Re: Hardware change notice. Intel Motherboard DQ965GF.

This is an official hardware change notice. In order to keep up with the rapidly changing technology and to improve the versatility of the end product, i³DVR will be changing the motherboard model for the entire line of Compact Wallmount DVRs, including Ultra Lite, Lite and SRX-Pro Hybrid models. In the next few months i³DVR will be switching from *ASUS P5B-VM* motherboard model to *Intel DQ965GF* model.

Figure 1. - Intel DQ965GF motherboard

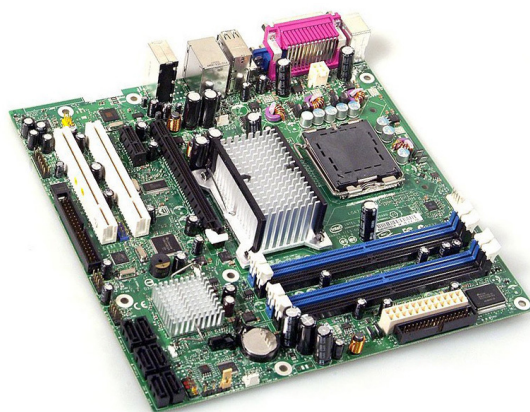
Among some of the clear advantages, Intel motherboard features a total of 6 Serial ATA (SATA) inputs and a total of 10 2.0 USB ports (6 external, 4 internal). *Intel DQ965GF* motherboard also supports up to 8GB of RAM and features 2 conventional PCI and 2 PCI Express bus connectors.
